**Engineering Support Services and Recommendations for Roadside Safety Issues or Problems
for Member States**

Engineering Opinion No. 20260901

MICHIGAN DOT 54-INCH FOUR-TUBE BICYCLE BRIDGE RAILING

Figure 2. Post Setback Criteria.

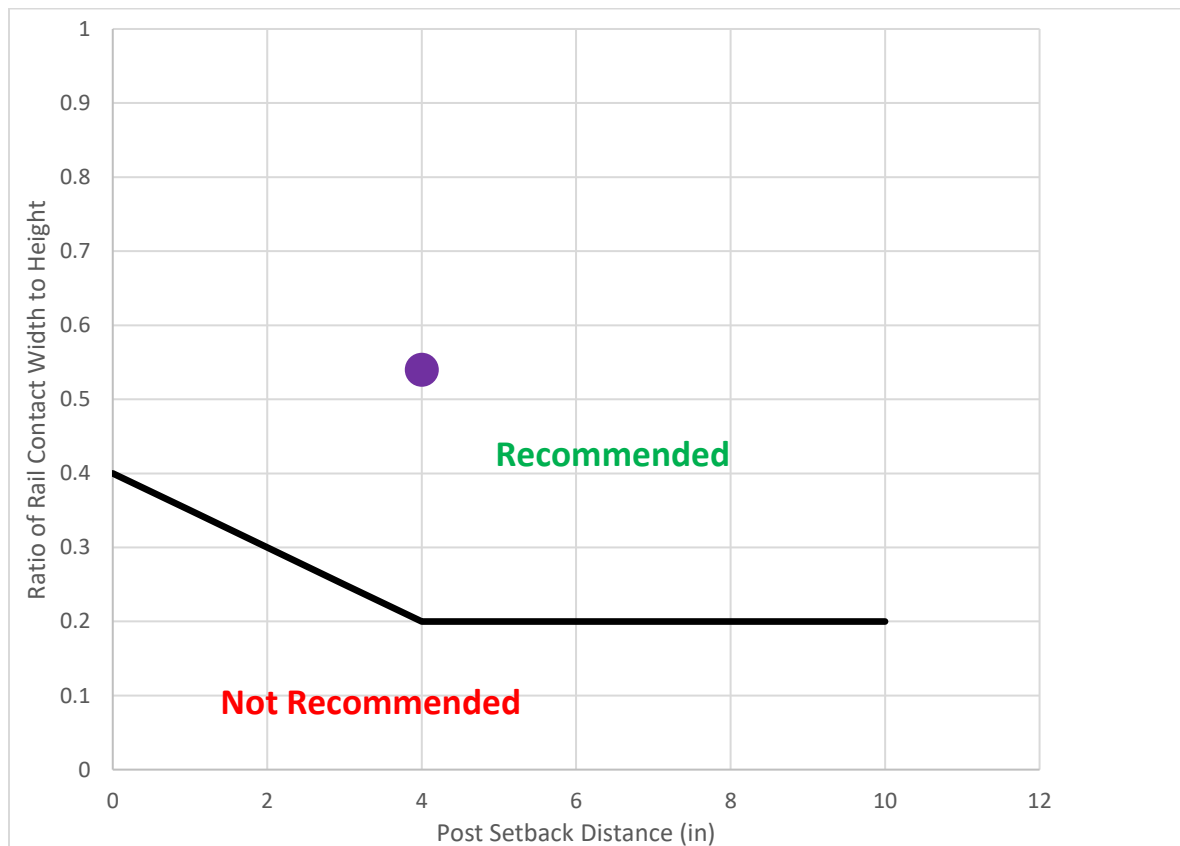
Post setback distance, ratio of contact width to height, and vertical clear opening were determined for the MDOT Four-Tube Bicycle Bridge Railing. The appropriate data points were plotted against updated AASHTO LFRD Section 13 geometric relationships established under NCHRP Project 22-35 (3). As seen in Figure 2 and Figure 3, the rail geometrics plot in the acceptable regions. Therefore, the snagging potential is low and the assessment of occupant risk is satisfactory. The MDOT Four-Tube Bicycle Bridge Railing meets the MASH TL-4 rail geometrics criterion.
